**Officer South Employment Precinct Structure Plan  
Draft Amendment C274card**

**Victorian Planning Authority Projects Standing Advisory Committee Referral 8 Report**

**6 June 2024**

Figure 8 PSP Plan 9 (Integrated Water Management)

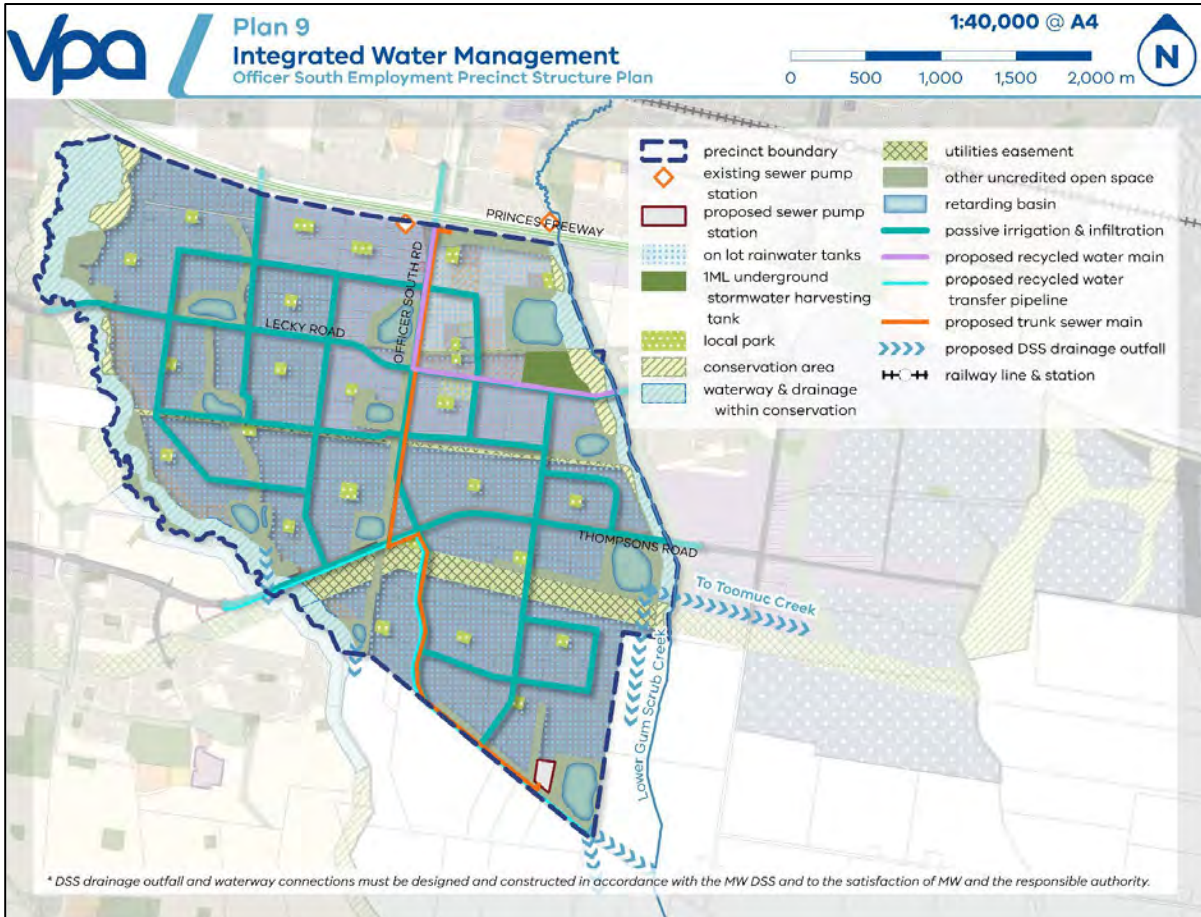
- i) Amend Plan 9 (Integrated Water Management) to:
- Remove the Stephens Road waterway. Retain the waterway on other plans only if there are other reasons (for example high value tree retention) which justify its retention.
  - Include some supporting text encouraging the implementation of the relevant Integrated Water Management initiatives in each 'pilot area'. This could be a note on Plan 9, or a Requirement or a Guideline in the appropriate section of the Precinct Structure Plan.
  - Remove references to Class A recycled water in pilot areas 1 and 3 if the use of recycled water would compromise the potential benefits of stormwater harvesting in reducing the total volume of stormwater in the system.
  - Correct the boundaries of pilot area 4 if required.

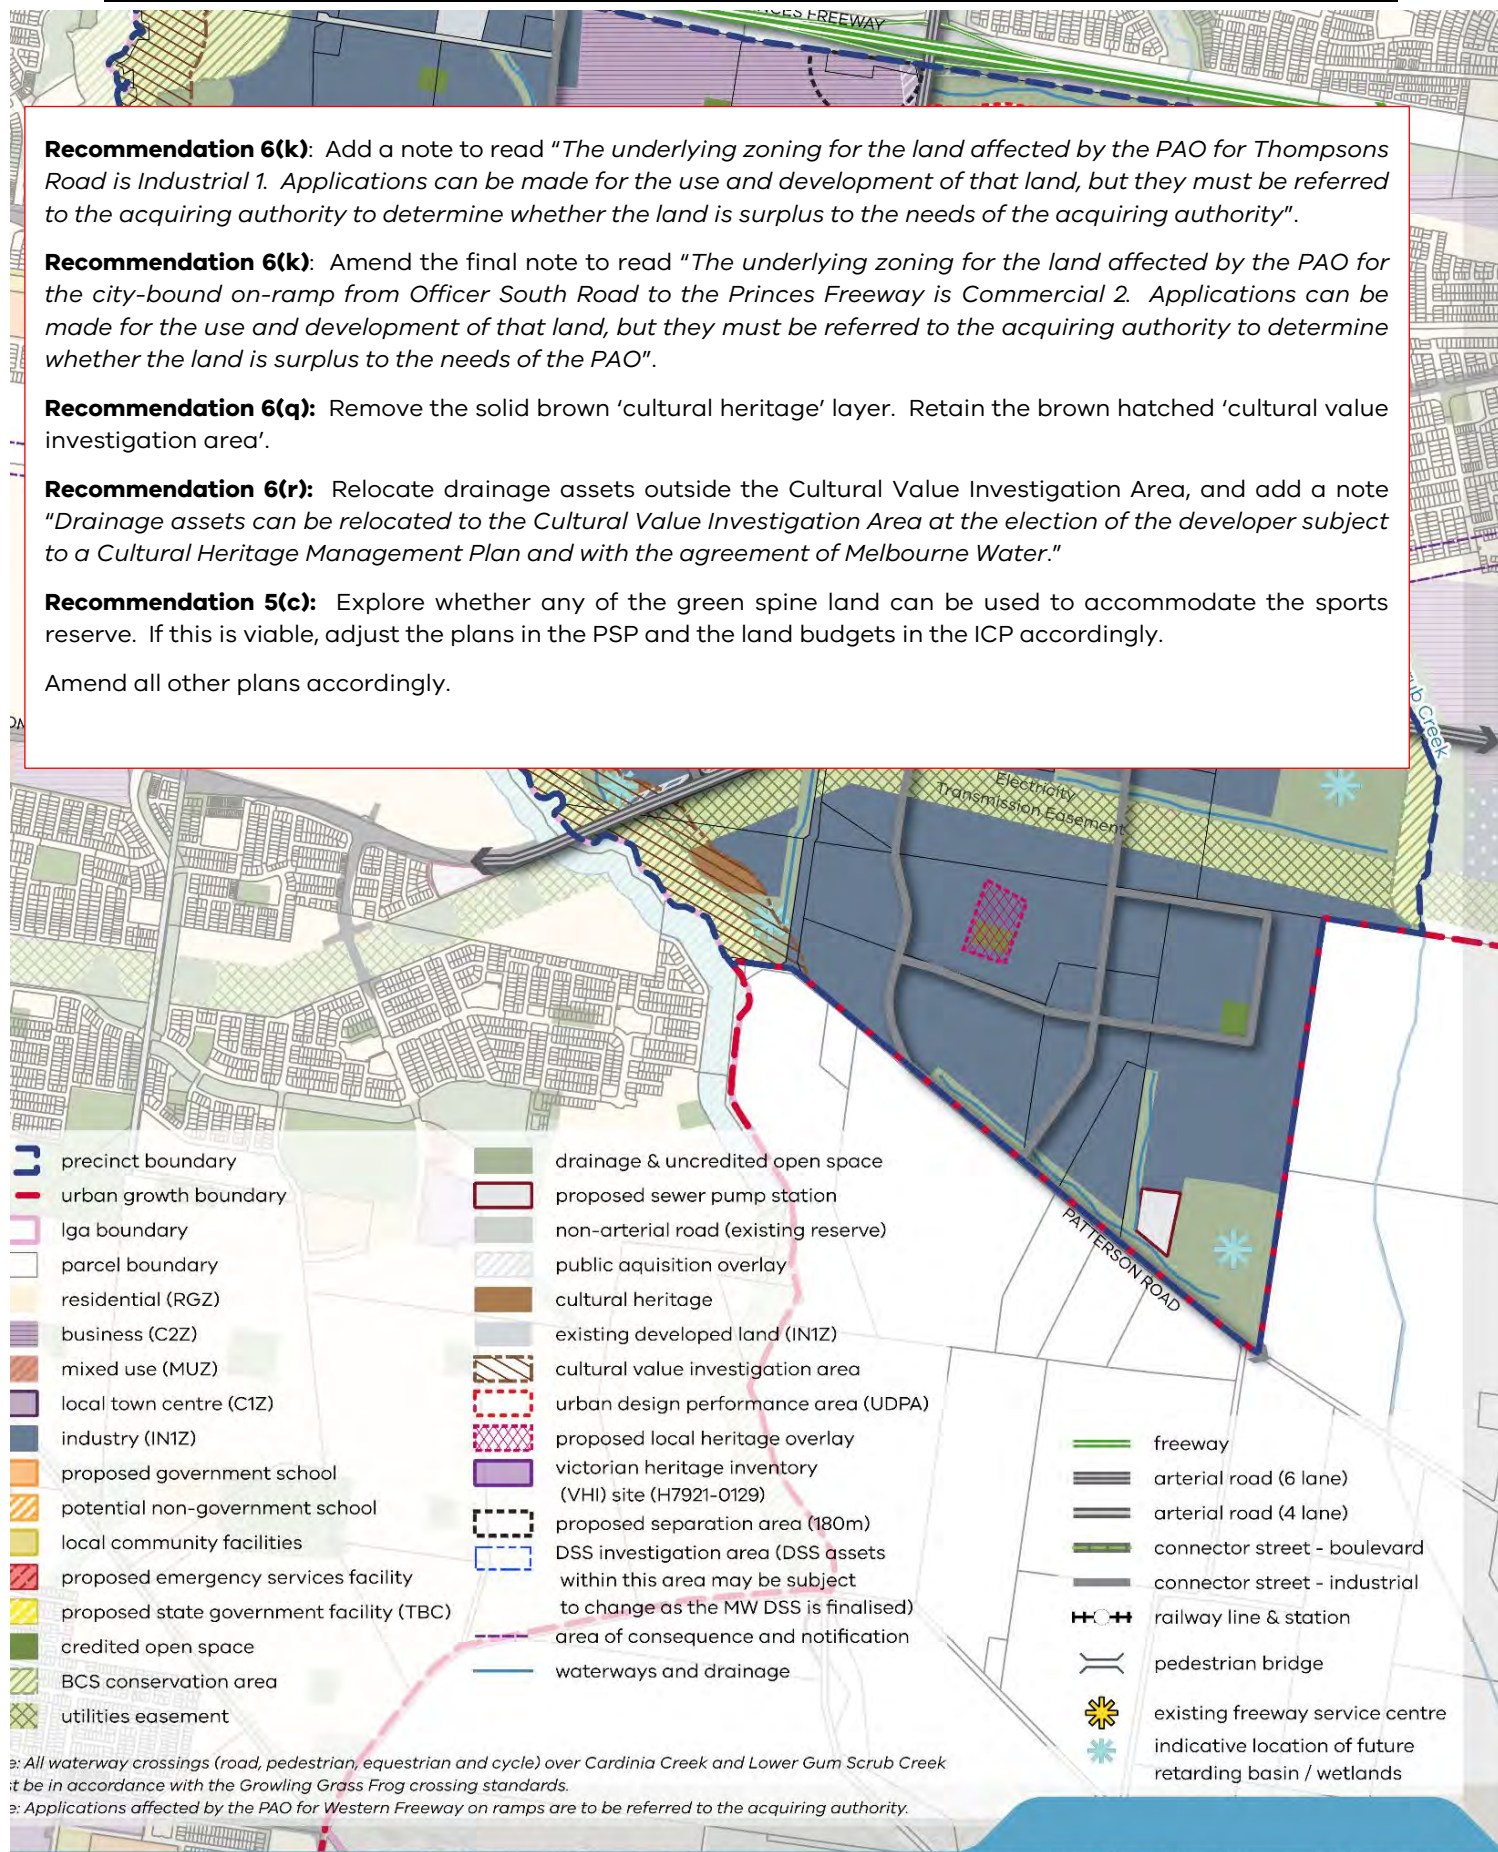
**Recommendation 6(k):** Add a note to read "The underlying zoning for the land affected by the PAO for Thompsons Road is Industrial 1. Applications can be made for the use and development of that land, but they must be referred to the acquiring authority to determine whether the land is surplus to the needs of the acquiring authority".

**Recommendation 6(k):** Amend the final note to read "The underlying zoning for the land affected by the PAO for the city-bound on-ramp from Officer South Road to the Princes Freeway is Commercial 2. Applications can be made for the use and development of that land, but they must be referred to the acquiring authority to determine whether the land is surplus to the needs of the PAO".

**Recommendation 6(q):** Remove the solid brown 'cultural heritage' layer. Retain the brown hatched 'cultural value investigation area'.

**Plan 7**  
**Native Vegetation Retention & Removal**  
 Officer South Employment Precinct Structure Plan

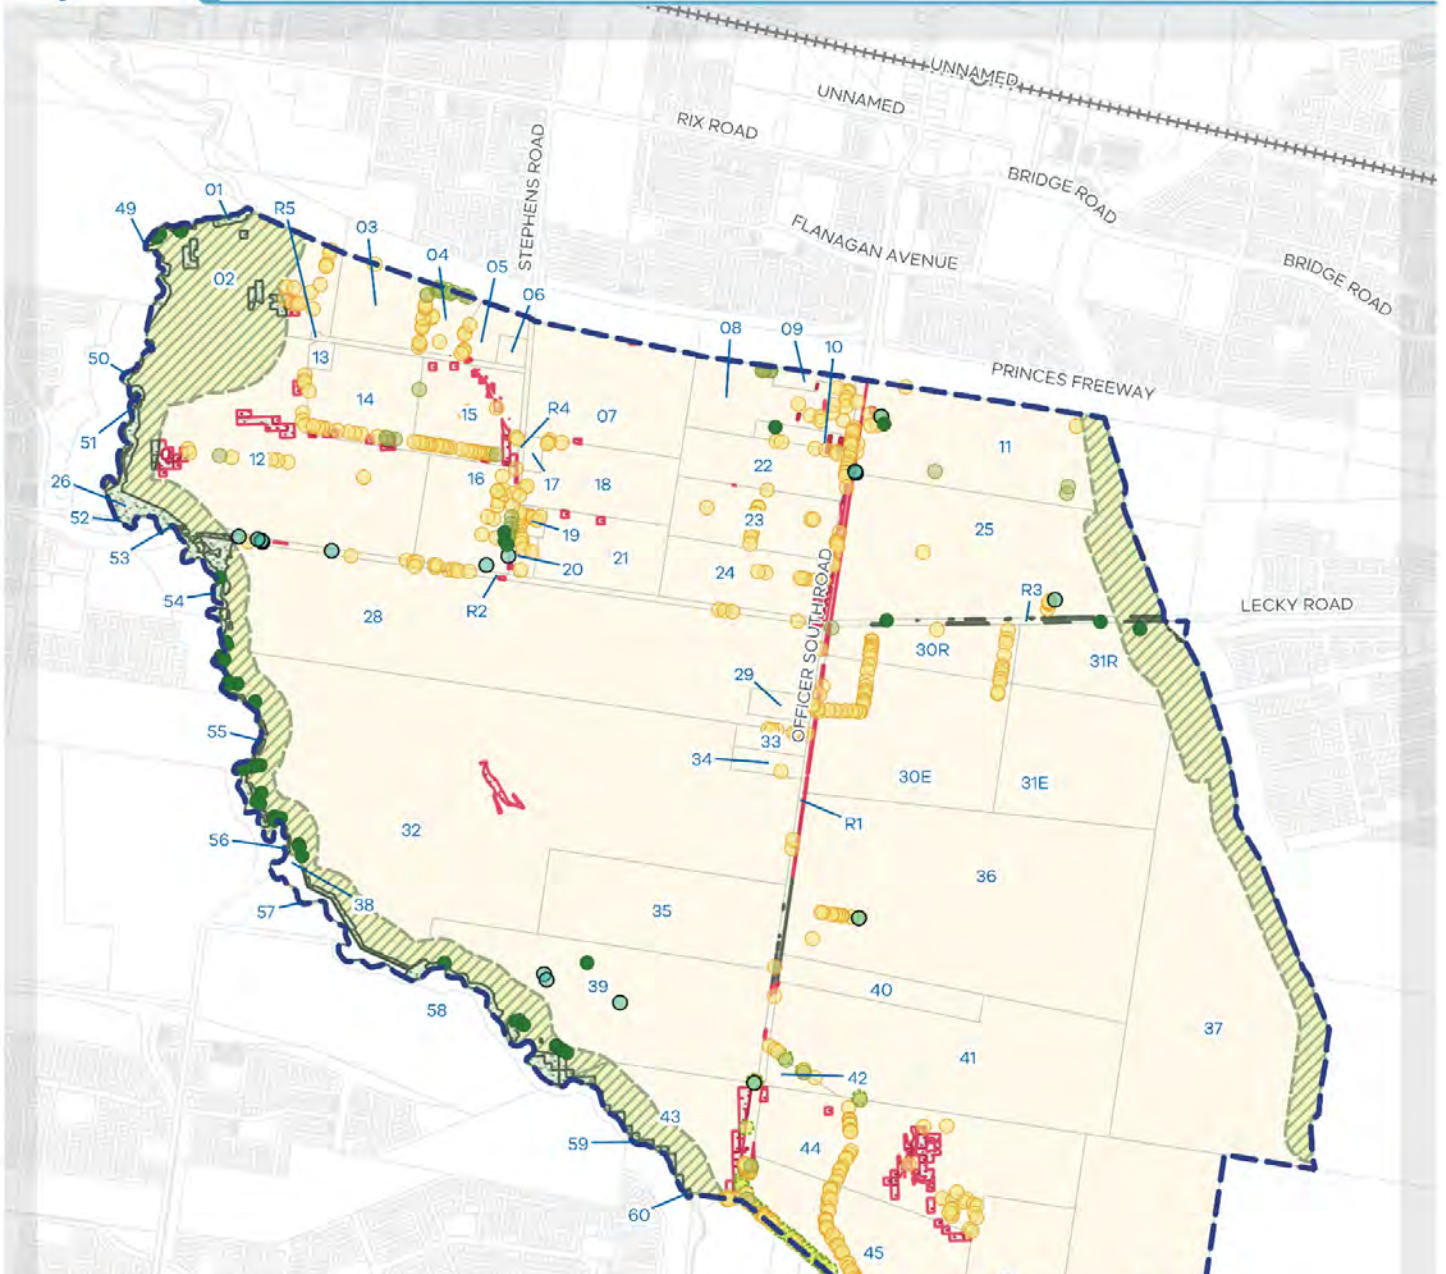
Add a note indicating trees to be retained are identified in the Preliminary Tree Assessment, Homewood Consulting, September 2020

**Plan 12**  
**Infrastructure and Development Staging**  
Officer South Employment Precinct Structure Plan

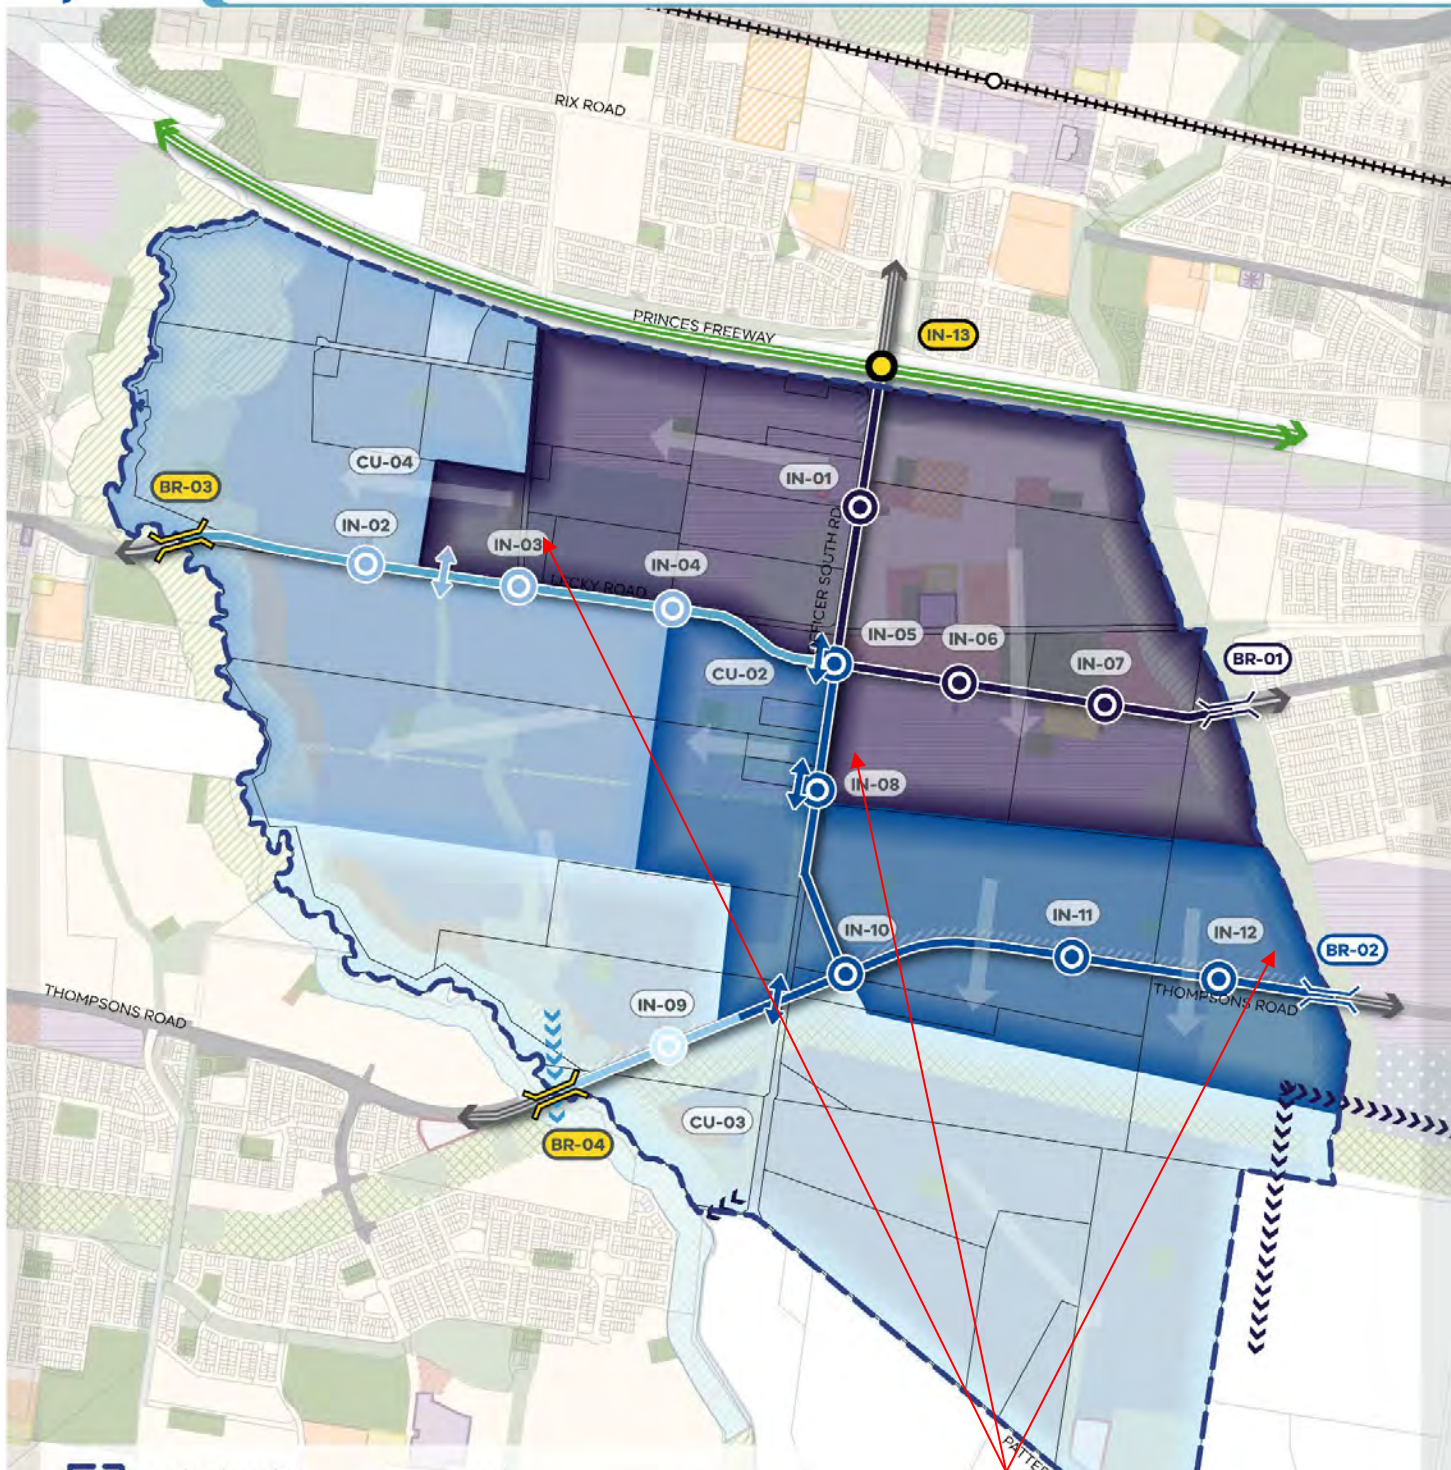
- l) If Plan 12 (Infrastructure and Development Staging) is to be retained in the Precinct Structure Plan, amend Plan 12 by:
- removing intersections IN-01 to IN-12, or

- alternatively, removing the colour coded depiction of the intersections which matches them to the proposed stages.
- m) If, contrary to the previous Recommendation, intersections are to remain on Plan 12 and linked to a particular stage of development:

- amend Plan 12 to show the whole of intersection IN-05 linked to Stage 1
  - include provisions in either the Precinct Structure Plan or the Urban Growth Zone Schedule 7 to require intersection IN-05 to be delivered in Stage 1.
